SUPPLEMENTAL NOTICE NO. 3

INVITATION TO BID NO. TIWS-S-04(R)

SUPPLY AND CONSTRUCTION OF 230 kV STATIC VAR COMPENSATOR AT  
KHLONG NGAE SUBSTATION

TRANSMISSION SYSTEM IMPROVEMENT PROJECT IN WESTERN AND  
SOUTHERN REGIONS TO ENHANCE SYSTEM SECURITY

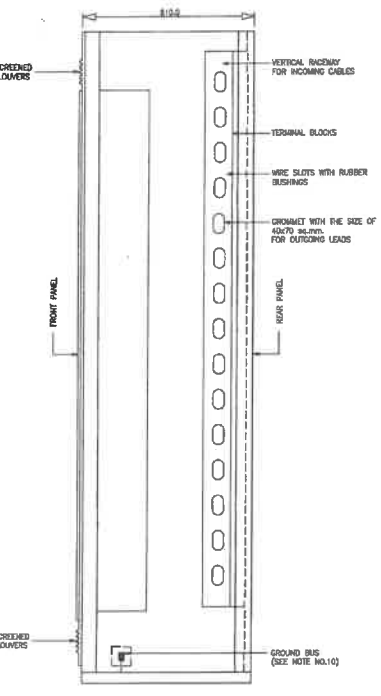
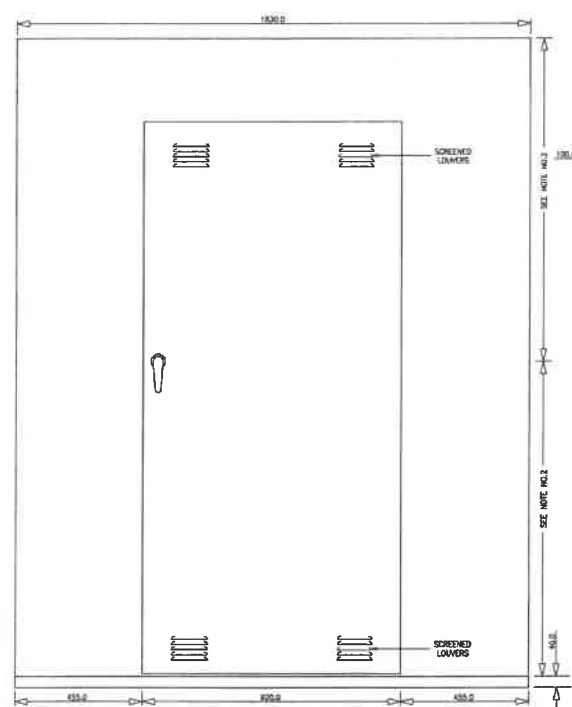
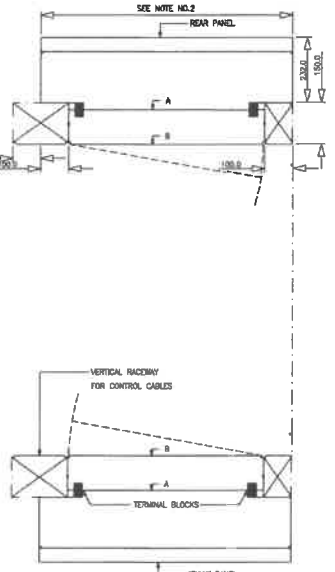
Replace Dwg No. TP-E-10.1 (Rev.6) with the revised one with (Rev.7) attached.

REV. NO.	JOB NO.	JOB DESCRIPTION	DRAWN	DESIGNED	VERIFIED	VALIDATED	RECOMMENDED	CONCURRED	APPROVED	DATE
7	-	REVISE THE DEFINITION FOR SWING RACK'S DEPTH	P. Rakkeung	-	-	-	-	-	-	-
6	-	REVISE THE SIZING OF TERMINAL LUG FOR GROUNDING CABLE, THE SIZING OF DUPLEX VERTICAL RACEWAY, CONTROL SWITCHBOARD-ENCLOSED TYPE LAYOUT AND NOTES	P. Rakkeung	-	-	-	-	-	-	-
5	-	ADDITION OF SCREENED LOUVERS	P. Rakkeung	-	-	-	-	-	-	-
4	-	ADDITIONAL NOTE 7.	S. Thinnokom	-	-	-	-	-	-	-
3	-	REVISE THE POSITION OF A VERTICAL RACEWAY IN THE SWING RACK TYPE, ADDITIONAL NOTES 4,5,8.	J. Surapong	-	-	-	-	-	-	-
